MEQUON MUNICIPAL WATER UTILITY COMMISSION

Regular Meeting

TO: Mequon Municipal Water Utility Commission
FROM: Kristen Lundeen, Director of Public Works/City Engineer
DATE: June 14, 2022
SUBJECT: Request from the Village of River Hills for Municipal Water Service

SUBJECT: River Hills Request for Connection to Mequon Water Utility

Attachment: Exhibit C - HHS Water Main Extension and Exemption (7361 : Application for Exemption to

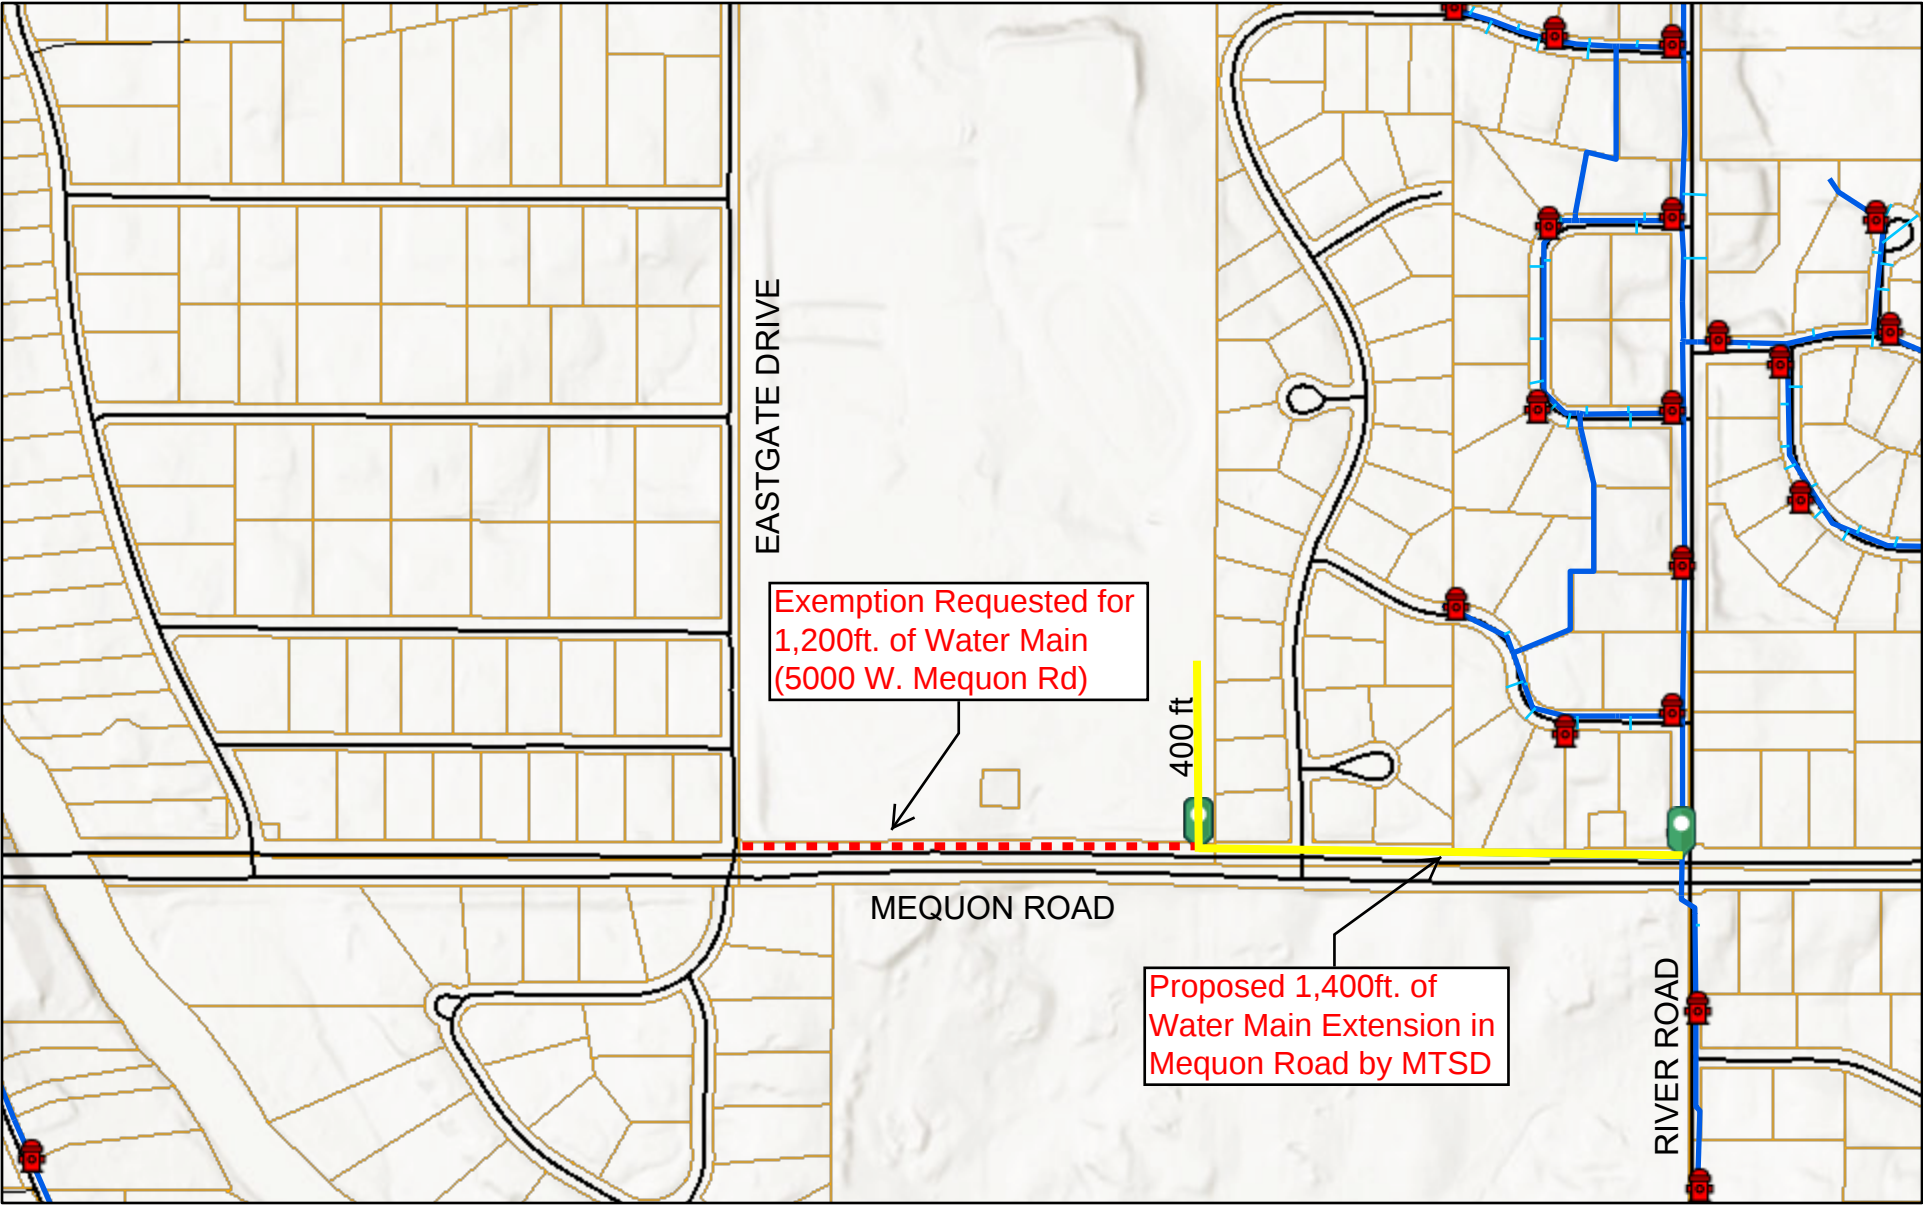
The proposed water main connection point by the MTSD for Homestead High School is on the east side of their development. The MTSD plans to construct approximately 1400 feet from the existing water main in River Road to the Homestead High School parcel. See Exhibit C.

Section XI of the Water Connection Policy requires water main extension along the entire parcel frontage. In this case on Mequon Road, that would be an additional 1200 feet of water main. That water main would extend to Eastgate Drive, and dead-end near the Mequon Country Estates subdivision. MWU staff has not received any requests or interest to service the Mequon Country Estates subdivision or River Trail Estates to the south. Both subdivisions are served by private systems. Also, in the 2017 Mequon Water Utility Master Plan, no water main extension was identified along Mequon Road crossing the Milwaukee River.

In this case, without customers, the utility would need to flush that dead-end main to maintain water quality. That extension was not included in the system plan, a dead-end would not benefit the utility, and it is anticipated that segment would be an un-used asset and potential liability.

Staff recommends the approval of this exemption to extend watermain along the entire frontage of the MTSD property on Mequon Road.

Exhibit 1 – Base Scenario

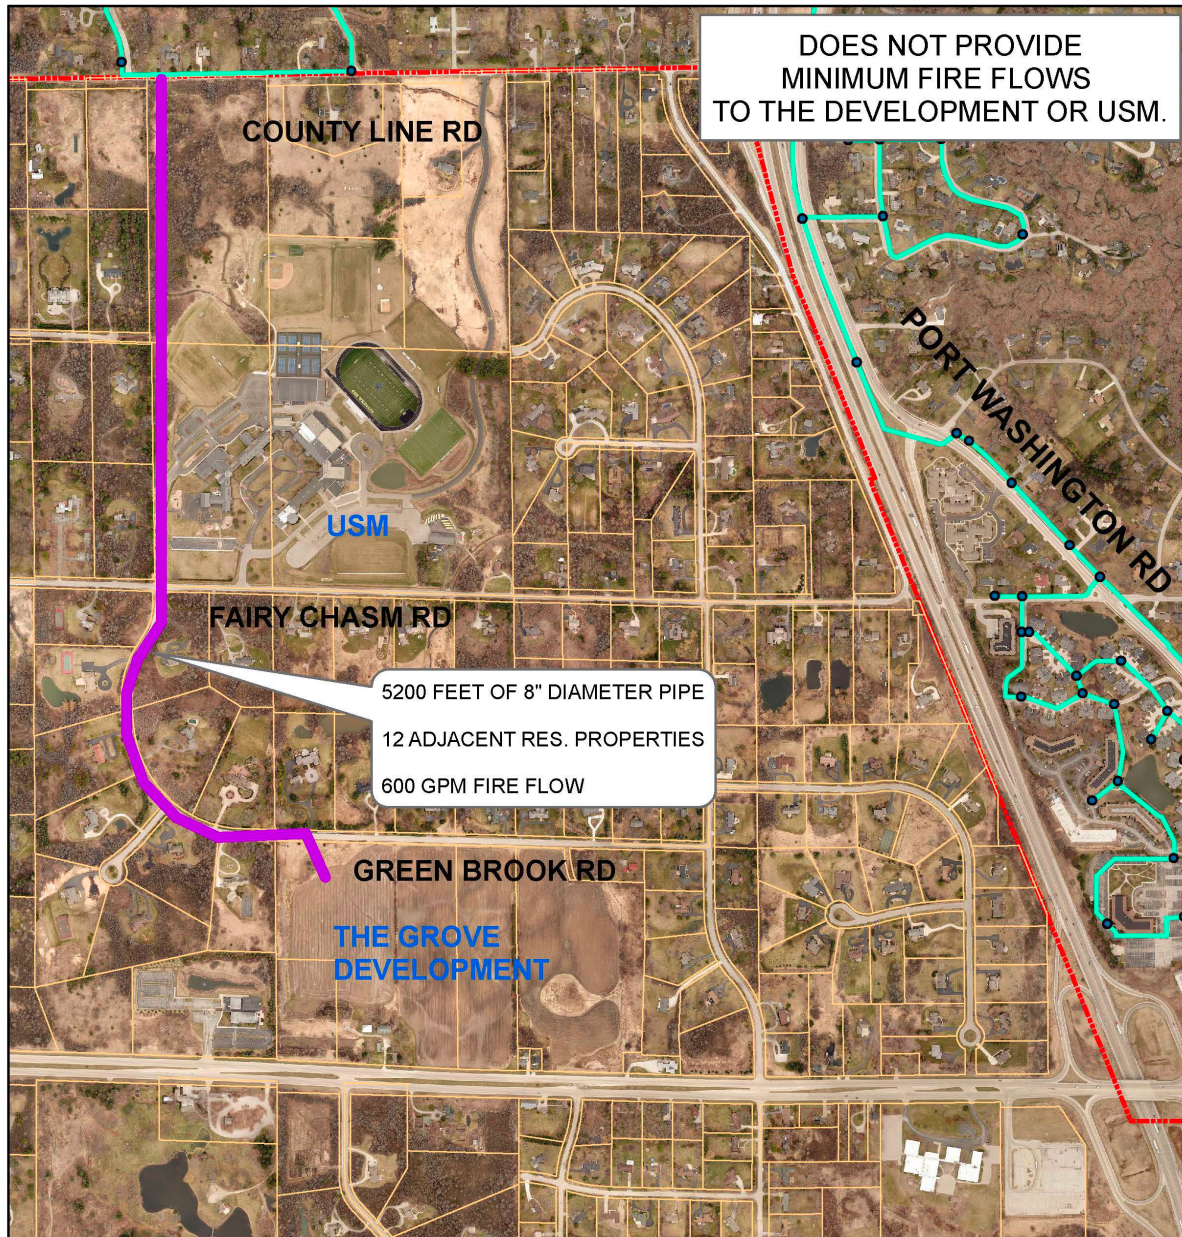
The results of the simulation show that static pressure provided to the development was at 66psi and the fire flows in the pipe were 600 GPM at 20psi residual pressure. The base scenario is shown in exhibit 1.

- The static pressure meets the requirements of NR811.70(4) of Wis. Stats. 66psi is greater than 35psi and less than 100psi.
- The fire flow is less than the recommended 1000 GPM, though higher than the minimum required 500GPM per NR811.70(6) of Wis. Stats.

This base scenario does not meet Mequon Water Utility recommendations for fire flows. Additionally, the water age in this system will be greater than 72 hours based on the simulation which is considered "long".

Exhibit 2 - Alternative 1

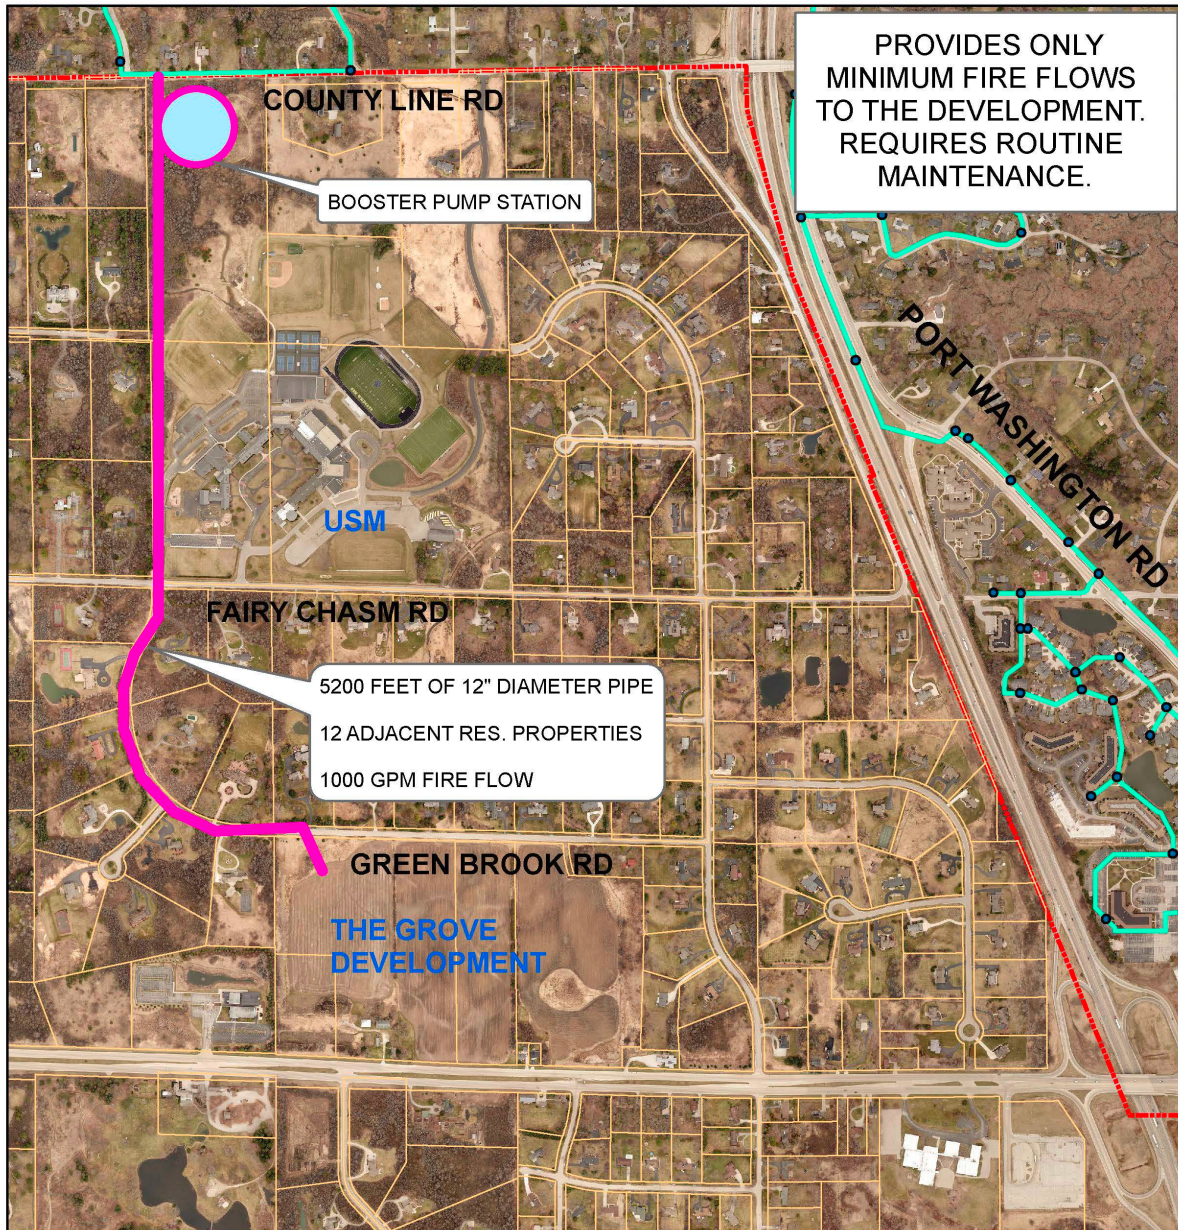
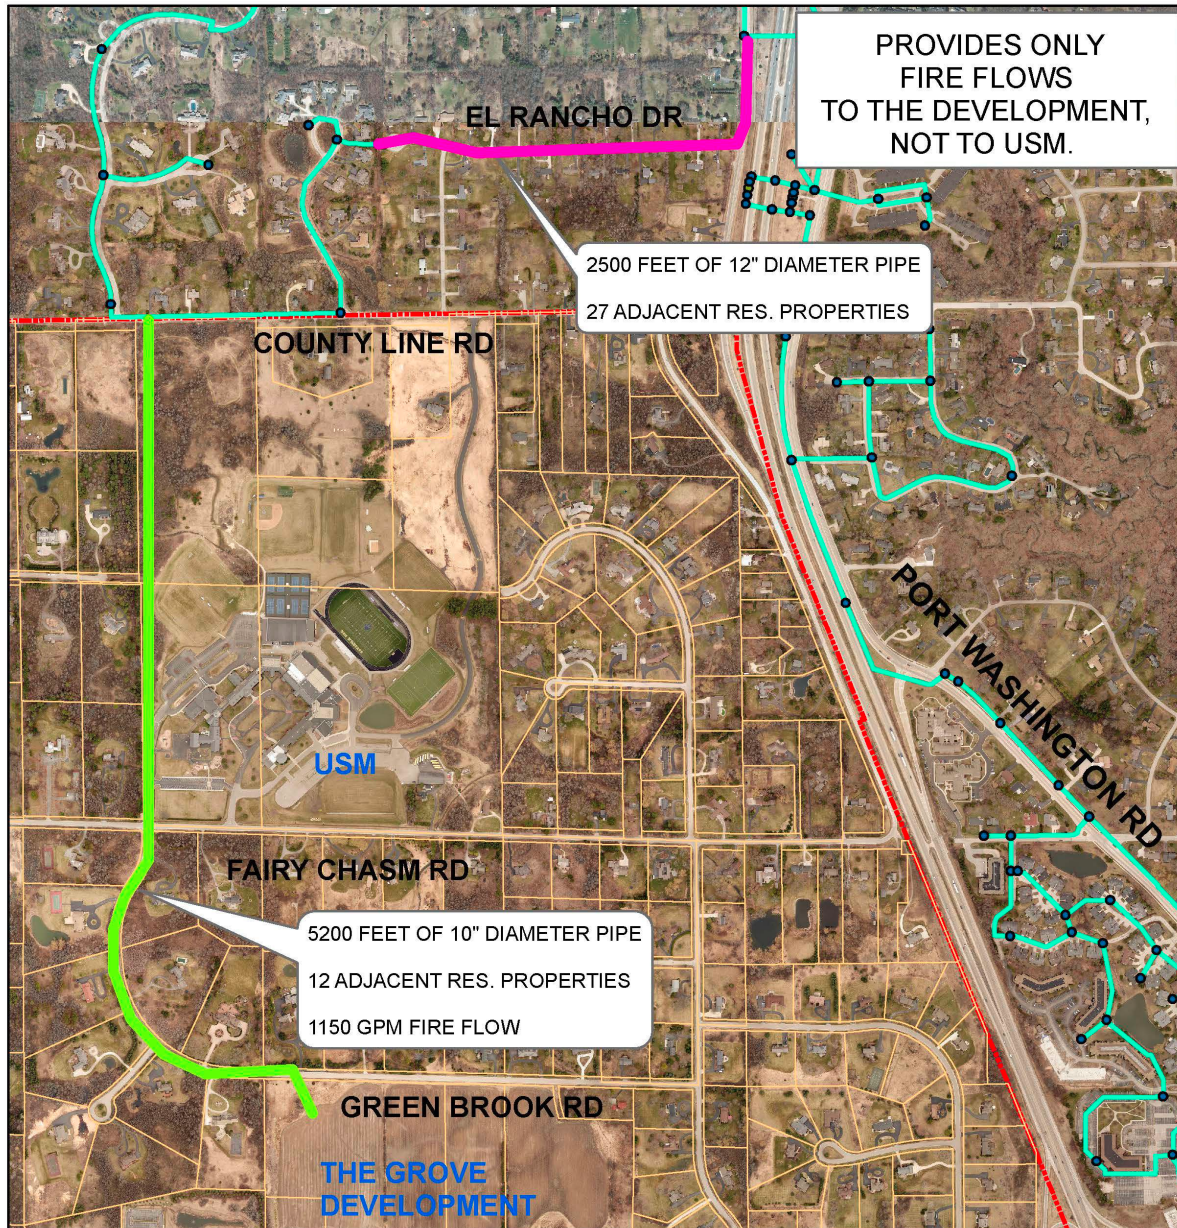
Alternate 1 utilizes a booster pump to increase the fire flows to the development. The pump was placed just south of the connection to the Mequon system. This scenario requires a 12-inch diameter pipe to the development. The booster pump operating at 80psi will provide the development with 1000GPM. Exhibit 2 shows Alternate 1. The booster pump was the least attractive of the options as it would require routine maintenance.

Pros	Cons
- Meets static pressure requirements of NR811 - Booster pump and larger diameter mains provide 1000 gpm residential fire flow	- Booster pump station require ongoing operation and maintenance costs not benefiting existing Utility customers - Oversize main and booster pump station increase initial capital costs and future capital replacement costs

Exhibit 3 shows Alternate 2 which includes a loop upstream of the River Hills connection. The Alternate 2 loop proposes a connection at the existing 16-inch watermain on Port Washington Ln approximately 500ft north of El Rancho Dr. A 12-inch pipe would then run south to El Rancho Dr then head west on El Rancho through the cul de sac to the existing 8-inch watermain on Columbia Creek Ln. This loop would increase the flow on the Mequon system at the River Hills connection point. The fire flow at the connection would increase from 800GPM to 1400GPM. The extension to the development via USM property and Greenbrook Rd. would need to be a 10-inch diameter pipe to provide a fire flow of 1050GPM. Additionally, this loop would provide opportunity for 27 new customer connections on El Rancho, should Mequon wish to explore that. Additionally, the water age shortens at the connection point, and is a benefit to fire flows in the area for existing customers.

Alternative 2 provides the first potentially viable option for the River Hills development. The system looping proposed eliminates one of the long-term looping projects on the Utility's Capital Infrastructure Plan. However, the deficit of over \$1 million at the end of the infrastructure's life cycle would be too large an impact on existing customers.

Exhibit 4 - Alternative 3

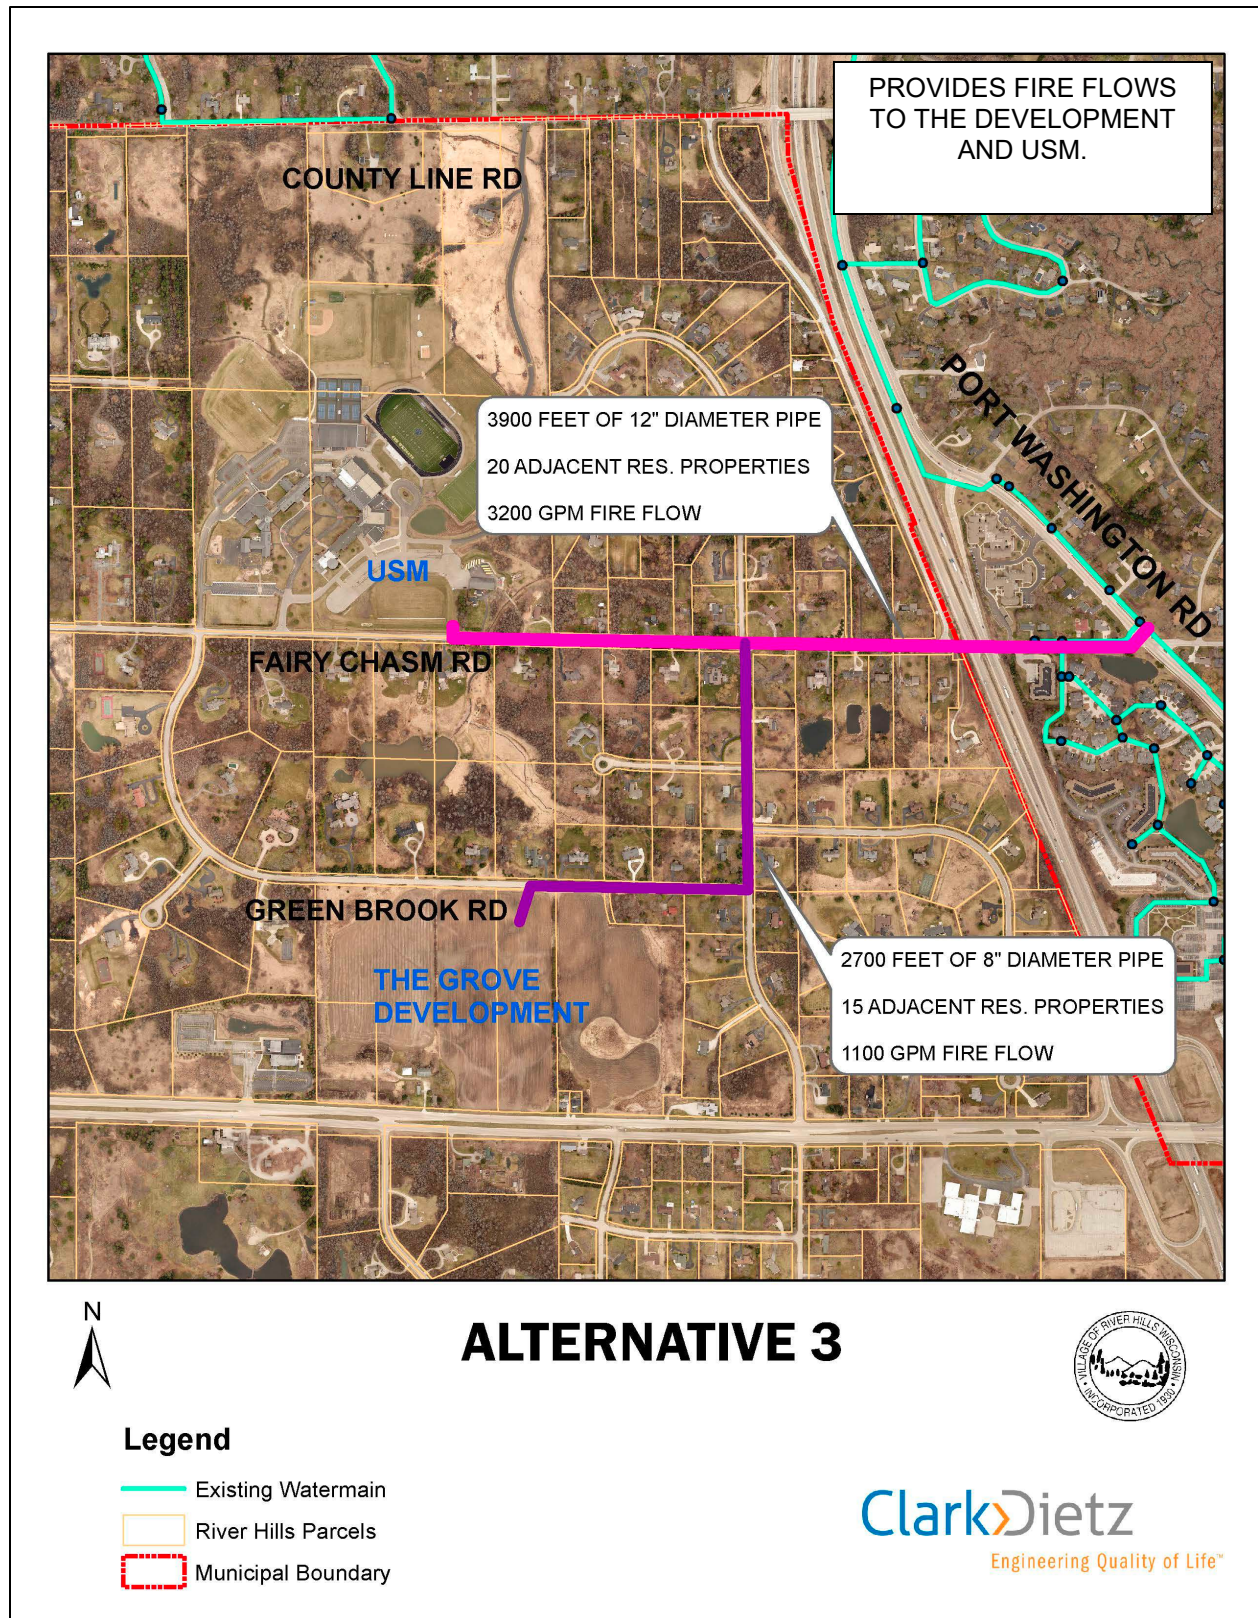
Exhibit 4 shows Alternate 3 which includes a connection to the Mequon Water Utility system in Bayside on Port Washington Rd where there is a 16-inch watermain pipe. A 12-inch diameter pipe would connect to this 16-inch and travel west on Fairy Chasm Rd, bore beneath I-43, and continue west to USM where a stub would be provided to the school. An 8-inch pipe would connect into Fairy Chasm 12-inch at the Spruce Rd intersection and travel south to Greenbrook Rd and then west to the development. This alternative would require 3900 ft of 12-inch watermain and 2700 ft of 8-inch watermain. The fire flow at the University School would be 3200GPM and the fire flows at the development would be 1100GPM, meeting the Mequon Water Utility requirements.

Pros	Cons
- Meets static pressure requirements of NR811 - Larger diameter main and Bayside connection provides 1000 gpm residential fire flow and 3200 gpm fire flow for USM - Adding USM as a customer would increase revenues over the life cycle – the capital costs are recouped in around 25 years - An additional 35 potential River Hills customers could be served by this routing - This alternative has no impacts on ability to provide domestic or fire flow to existing customers.	Interstate crossing involves substantial operational risk to the Utility. If the main underneath the interstate were to fail, USM and River Hills customers would be without water for potentially weeks while a new main was installed under the interstate.

Alternative 3 is by far the most appealing option from providing both domestic and fire flow to the proposed development without impacting existing customers. The largest concern is the future risk of the interstate crossing failing and the Utility being unable to provide water to River Hills and USM. Potential solutions to this issue include:

- Requiring a casing under the interstate for ease of replacement/repair. Currently the Clark Dietz analysis does not include casing in the estimated cost of Alternative 3. Mequon Water Utility currently has two interstate crossings, and both have casing pipes for safety and ease of repair/replacement.
- Requiring a small diameter (8-inch) looping main back to County Line Rd and a boundary valve. Even with a casing under the interstate, repairs/replacements of any damage or failure could take several days/weeks to fix. A small diameter looping main would allow the Utility to provide domestic flow to River Hills and USM during the interstate crossing repair.

1. Execution of the IGA is conditioned upon University School Milwaukee connecting to the Mequon Water Utility with the construction of the initial project.
2. Casing required for the water infrastructure under the interstate crossing.
3. Loop 8-inch diameter main from development back to County Line Road with a boundary valve.
4. Mequon Water Utility approval of the design, technical specifications and construction plans prior to bidding.
